Design Guidelines Figure A –  
Riverside Land Conservancy Letter

## Riverside Land Conservancy

May 11, 2005

Planning Commission  
City of Riverside  
Riverside City Hall  
3900 Main Street  
Riverside, CA 92501

# Springbrook Wash Lower Zone

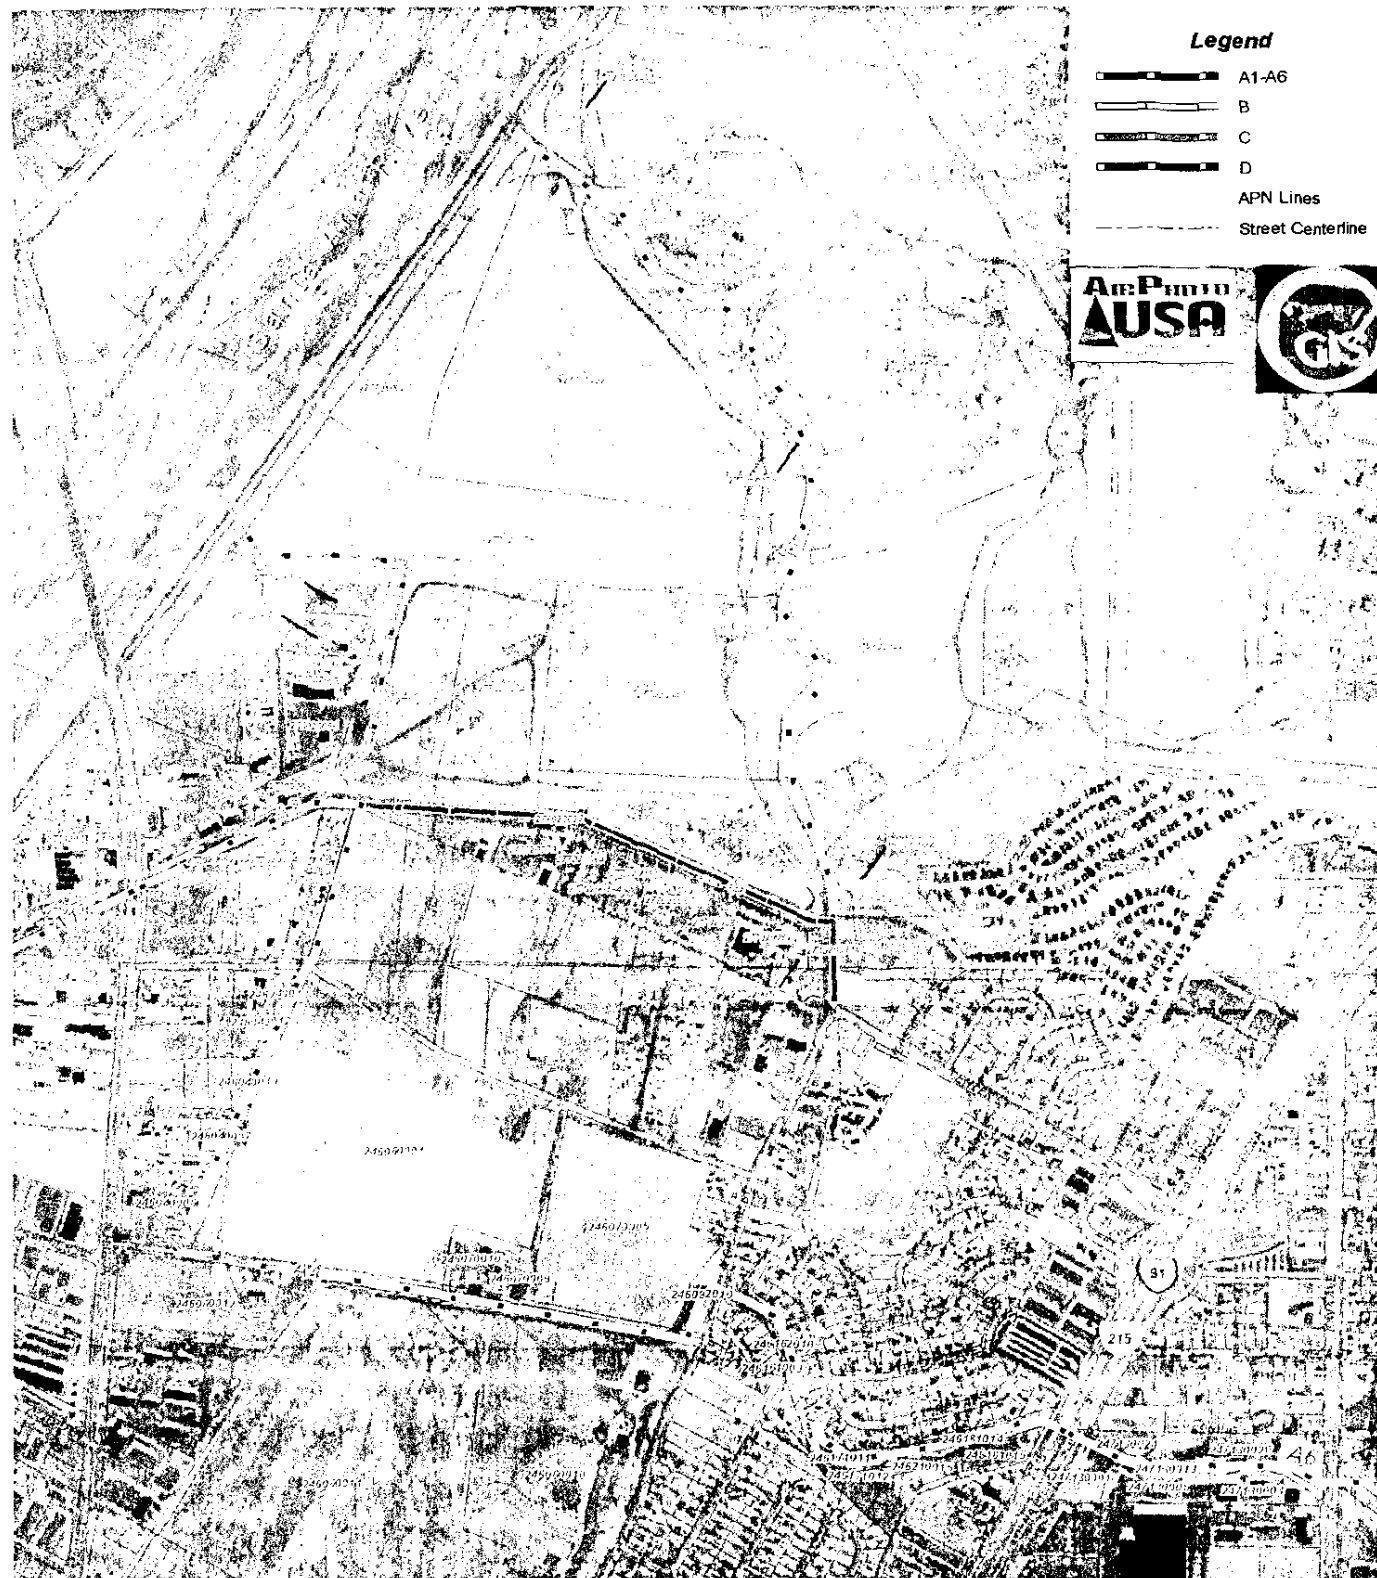
We respectfully request the Springbrook Wash Trail alignment be slightly revised in the General Plan Figure PR-1 to reflect the alignments presented in the RLC letter to the City Planning Director dated February 25, 2005, (copy attached hereto). Discussions the RLC has had with City and County Parks and Planning Staff indicates support of the proposed Trail alignment.
